AMENDMENT OF SOLICITATION/MODIFICATION OF CONTRACT			1. CONTRACT ID CODE	PAGE OF PAGES 1 32
2. AMENDMENT/MODIFICATION NO. 0005	3. EFFECTIVE DATE 27-Feb-2012	4. REQUISITION/PURCHASE REQ. NO.		5. PROJECT NO.(If applicable) PSPS060801PS

14. DESCRIPTION OF AMENDMENT/MODIFICATION (Organized by UCF section headings, including solicitation/contract subject matter where feasible.) Project No: PSPS060801PS - Ministry of Interior Supply Point @ Qalat. The purpose of this amendment is to provide revisions to sections 00010 and 01010, replace drawing 00 Concept Site Plan in Appendix A, and add drawing 05b Pump House to Appendix A. The proposal due date of 7 March 2012 @ 5:00 pm remains unchanged. See continuation page, block 14 for detail.				
Except as provided herein, all terms and conditions of the document referenced in Item 9A or 10A, as heretofore changed, remains unchanged and in full force and effect.				
15A. NAME AND TITLE OF SIGNER (Type or print)		16A. NAME AND TITLE OF CONTRACTING OFFICER (Type or print)		
		TEL: _____ EMAIL: _____		
15B. CONTRACTOR/OFFEROR	15C. DATE SIGNED	16B. UNITED STATES OF AMERICA		16C. DATE SIGNED

SUMMARY OF CHANGES

**SECTION 00010 (AMENDMENT 0005)
PROPO

MSP - CONCEPT SITE PLAN

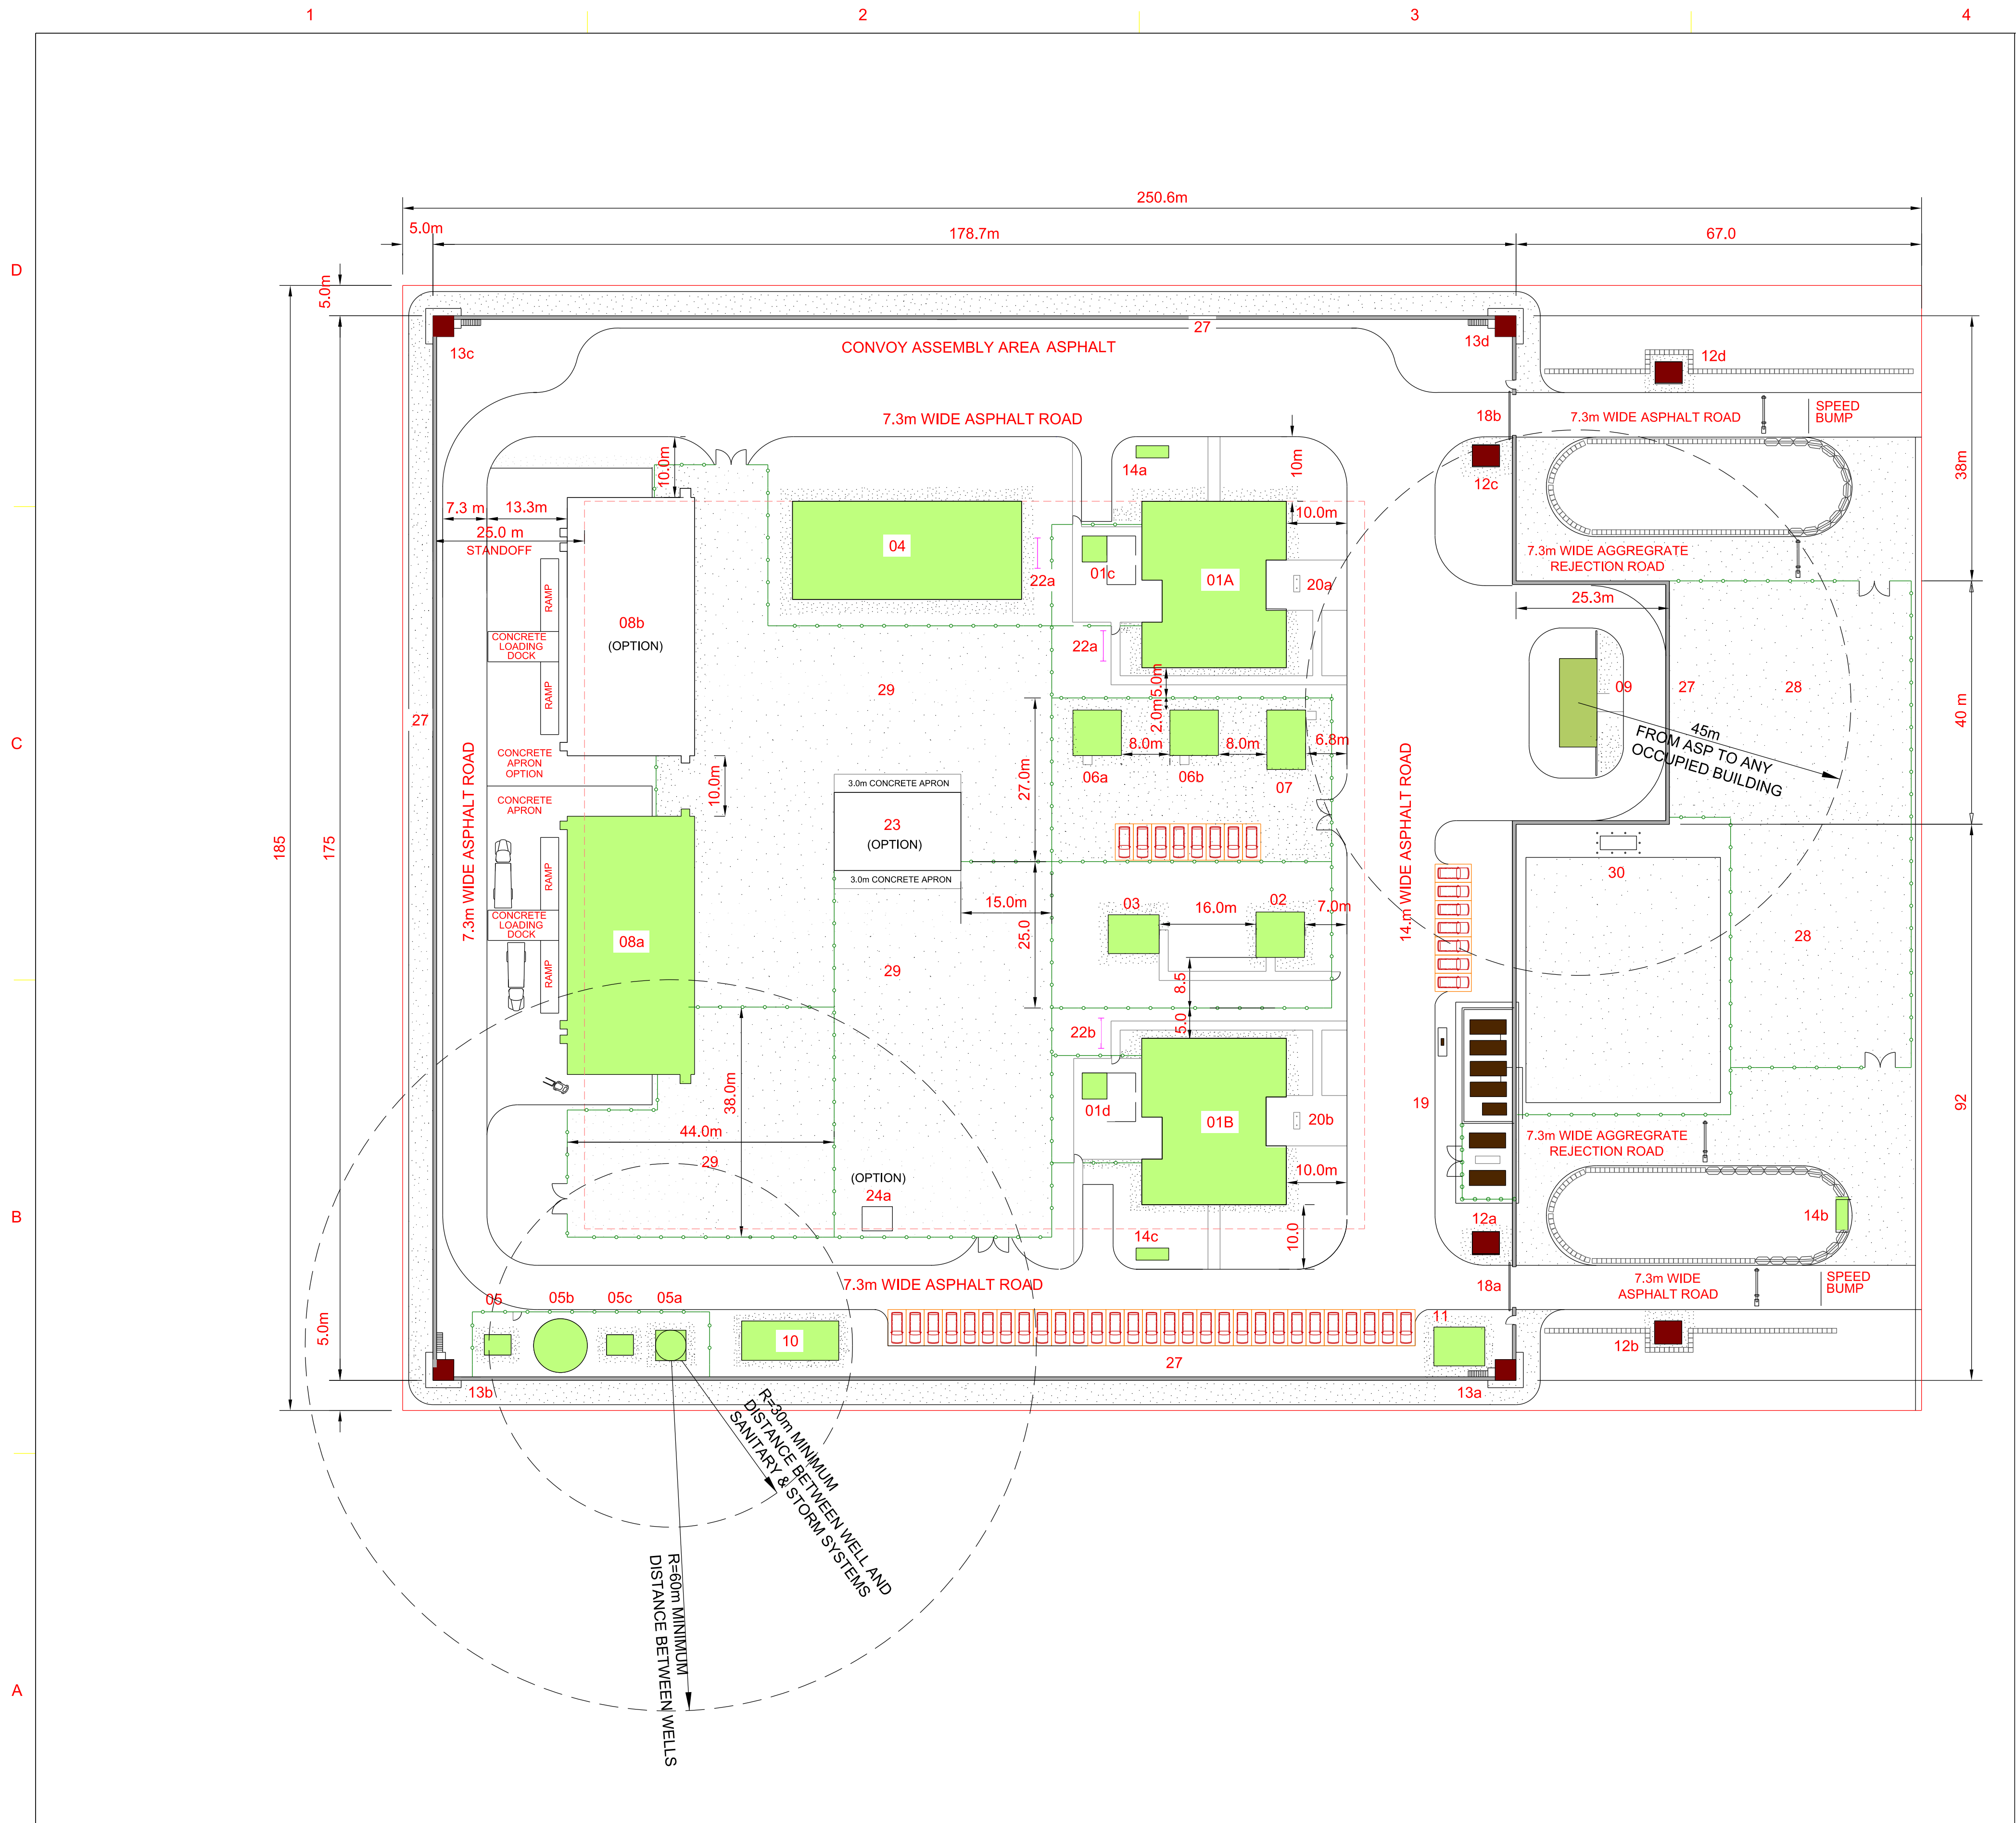
Drawing 00 Concept Site Plan provided in this amendment replaces all previous versions issued in their entirety.

ANA KANDAK
QALA-E-NAW
AFGHANISTAN
WATER BOOSTER STATION
WATER BOOSTER/WELL
HOUSE PLAN

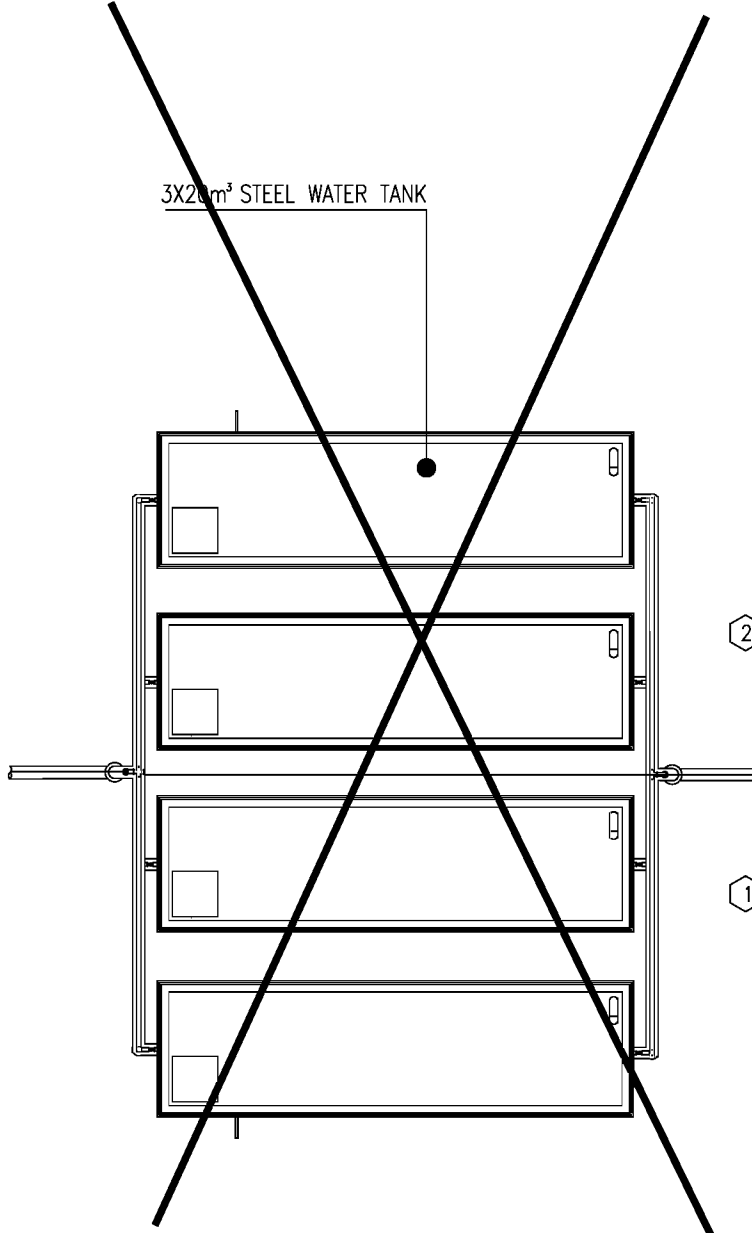
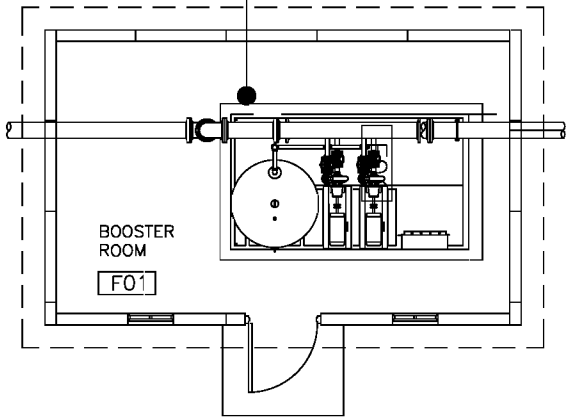
Drawing 05b Pump House provided in this amendment is added.

Construct one (1) Pump House in accordance with the provided Standard drawings entitled “05b Pump House” located as approximately illustrated on Concept Site Plan.
